9 July 2021

Re: McPhillamys Gold Project - DPIE Response - GHG assessment

Re: McPhillamys Gold Project - DPIE Response - GHG assessment

Figure 1.1 Annual GHG emissions inventory breakdown by year – Amended Project (EMM 2020)

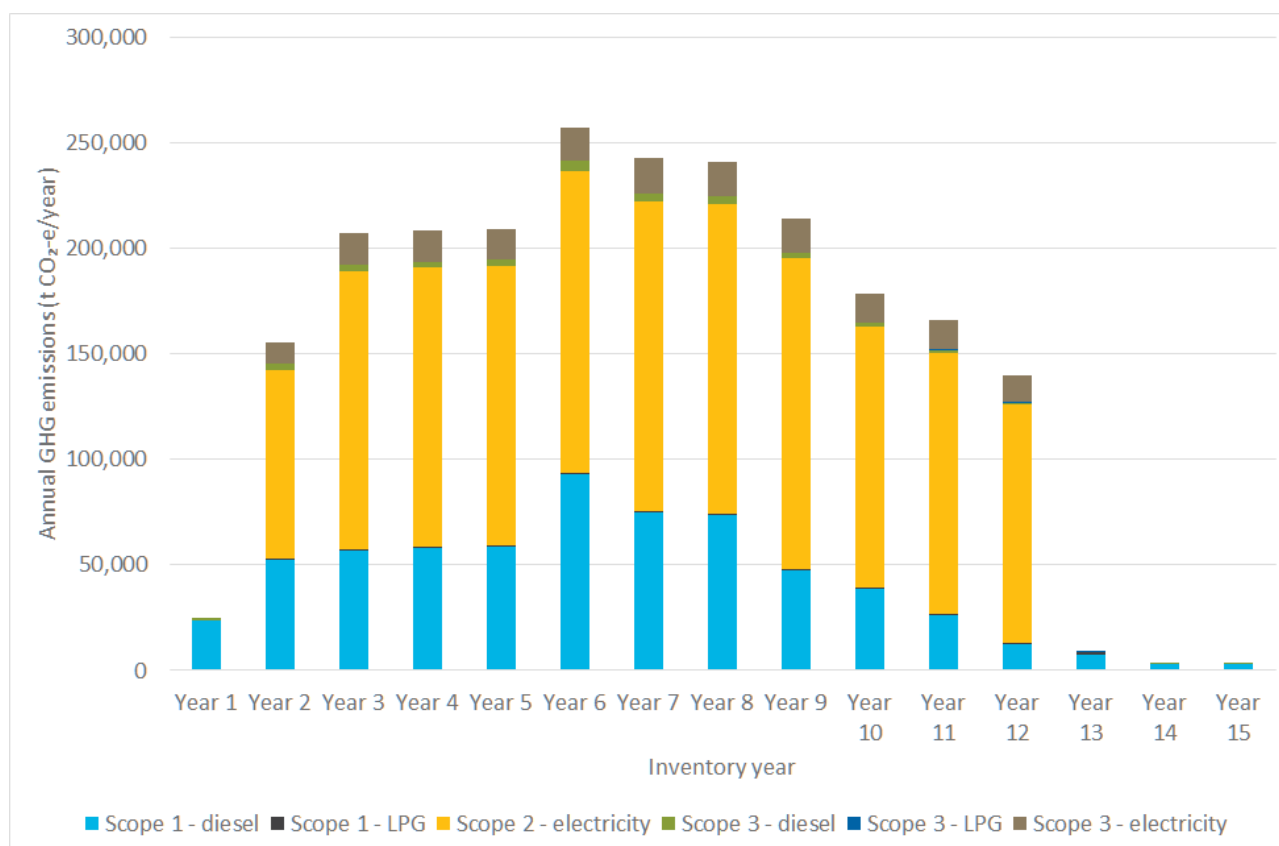
The RFI asks for a comparison of GHG emissions intensity before and after the project. As the project is not currently an active operation, it is not relevant or possible to calculate and compare the intensity of GHG emissions before and after the project.

Annual GHG emissions by source type and scope, as documented in the Amended Project air quality impact assessment (EMM 2020), are illustrated in Figure 1.1. Gold production from the project commences in mine year 2.

Over the project’s 15-year life, predicted annual GHG emissions are highest during the 11 years of material extraction and processing (year 2 to year 12). Overall, scope 1, 2 and 3 GHG emissions from the project are dominated by electricity consumption (scope 2) and diesel combustion (scope 1).

The intensity of GHG emissions (scope 1 and 2) from the project relative to the annual projected gold production were calculated. The emissions intensity ranges from 0.62 to 2.81 kg CO₂-e/oz gold produced by the project, with an annual average intensity across the life of the project of 1.25 kg CO₂-e/oz gold produced. Emissions intensity is greatest from the project during years 6 to 8 due to an increase in the rate of waste rock extraction relative to gold production, and the associated diesel consumption by the mining fleet and haul trucks.

As illustrated in Figure 1.1, the GHG emissions from the project are principally associated with on-site energy consumption, specifically diesel combustion by mobile mining equipment and plant and the consumption of purchased electricity by the processing plant.

As illustrated in Figure 1.1, the predicted annual scope 3 emissions are relatively minor in comparison to scope 1 and 2 emissions from the project. Furthermore, scope 3 emissions are outside the control of Regis, limiting the potential for mitigation measures to be implemented.

Figure 1.1 Annual GHG emissions inventory breakdown by year – Amended Project (EMM 2020)

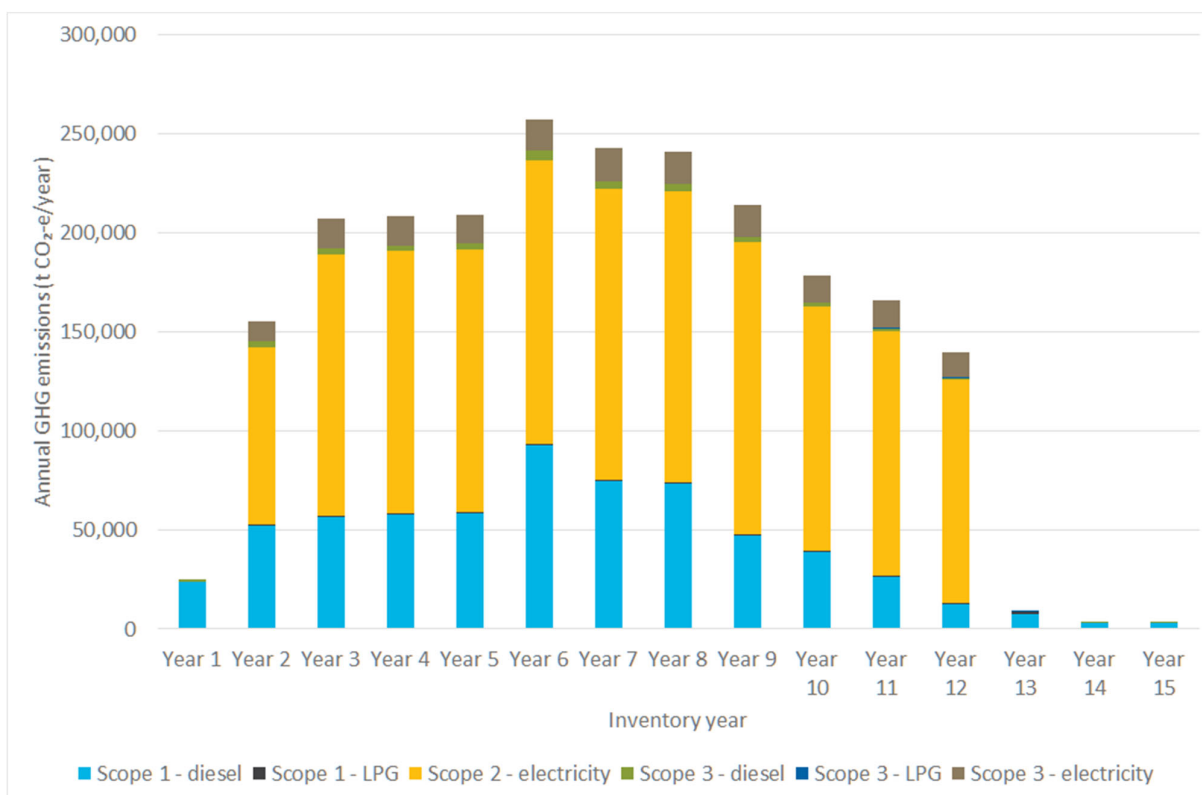
The RFI asks for a comparison of GHG emissions intensity before and after the project. As the project is not currently an active operation, it is not relevant or possible to calculate and compare the intensity of GHG emissions before and after the project.

Annual GHG emissions by source type and scope, as documented in the Amended Project air quality impact assessment (EMM 2020), are illustrated in Figure 1.1. Gold production from the project commences in mine year 2.

Over the project’s 15-year life, predicted annual GHG emissions are highest during the 11 years of material extraction and processing (year 2 to year 12). Overall, scope 1, 2 and 3 GHG emissions from the project are dominated by electricity consumption (scope 2) and diesel combustion (scope 1).

The intensity of GHG emissions (scope 1 and 2) from the project relative to the annual projected gold production and run of mine (ROM) ore processed were calculated. The emissions intensity for the project are:

- relative to projected annual gold production – the emissions intensity ranges from 0.62 to 2.81 t CO₂-e/oz gold produced by the project, with an annual average intensity across the life of the project of 1.24 t CO₂-e/oz gold produced.
- relative to projected annual ROM ore processed - the emissions intensity ranges from 0.02 to 0.05 t CO₂-e/t ROM ore processed by the project, with an annual average intensity across the life of the project of 0.03 t CO₂-e/oz gold produced.

Emissions intensity is greatest from the project during years 6 to 8 due to an increase in the rate of waste rock extraction relative to gold production, and the associated diesel consumption by the mining fleet and haul trucks.

As illustrated in Figure 1.1, the GHG emissions from the project are principally associated with on-site energy consumption, specifically diesel combustion by mobile mining equipment and plant and the consumption of purchased electricity by the processing plant.

As illustrated in Figure 1.1, the predicted annual scope 3 emissions are relatively minor in comparison to scope 1 and 2 emissions from the project. Furthermore, scope 3 emissions are outside the control of Regis, limiting the potential for mitigation measures to be implemented.
